My reference 050233

Your reference APP/22/01072

81C London Road, Waterlooville, PO7 7EL

Demolition of existing building for the construction of 15No. flats with two Class E (Commercial, Business and Service) units on ground floor with bin and cycle store.

Drawing KAD/10/A/PP Rev C shows vehicular visibility splays and pedestrian intervisibility splays for the proposed access. Whilst both visibility splays are drawn in accordance with HCC TG3 for a 30mph design speed, they seem to be obstructed as shown below:

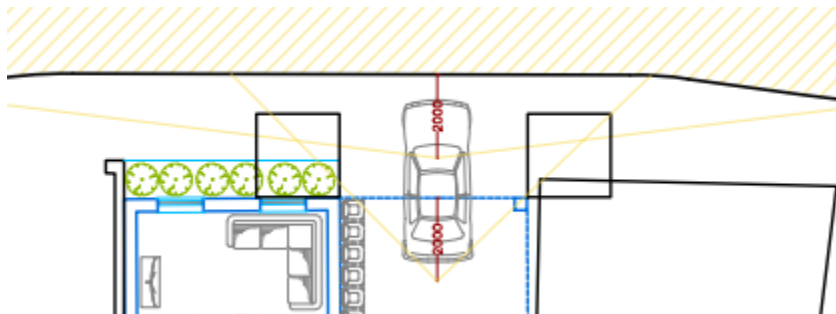
Clarity is requested as to what is obstructing the visibility splay. Any obstruction to the visibility splay must not exceed 600mm in height and must either fall under the ownership of the applicant or the Highway Authority to ensure maintenance in perpetuity should this be required. Confirmation should be provided on the ownership in this location. Visibility will be secured through an appropriate planning condition.

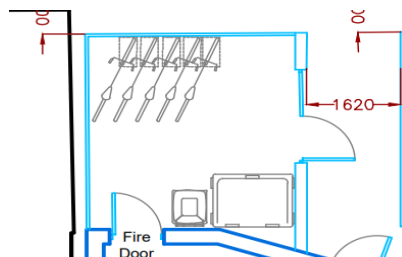
Forward visibility splays should also be provided. Considering the nature of the access point, the applicant must ensure that appropriate forward visibility can be achieved so that vehicles accessing and egressing are able to see each other at an appropriate distance. This should be supported by tracking for the largest vehicle expected to access the site to ensure that vehicles are able to access the site appropriately.
